In Reply Refer To:
Docket: 50-267/85-17

October 16, 1985
Fort St. Vrain
Unit No. 1
P-85367

SUBJECT: I&E Inspection Report 85-17

FIGURE 1 CIRCULATOR TRIP LOGIC

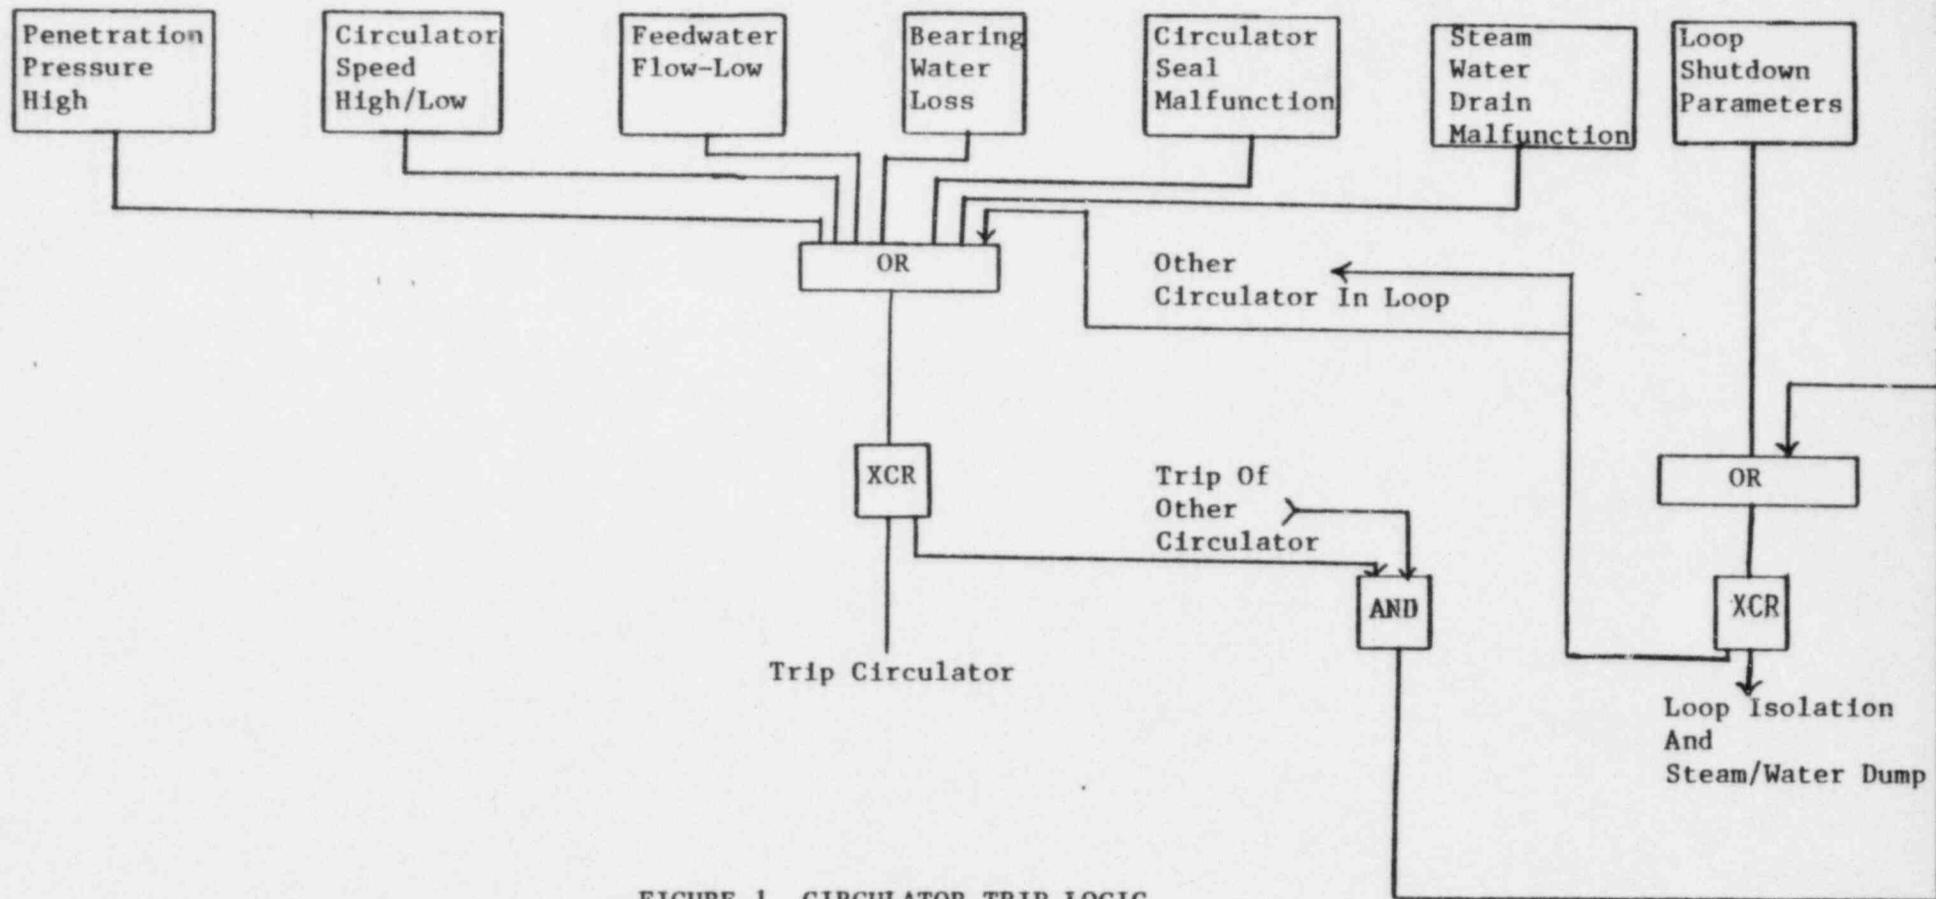
Figure 1 shows a simplified schematic for the inputs that can cause a circulator trip. Those inputs listed under equipment malfunctions are the only ones which result in a single circulator trip. Note that each parameter is associated with an abnormal condition for a single circulator. The ESF (loop shutdown) actuation of a circulator trip always causes both circulators in the loop to trip. This latter is a reportable event.
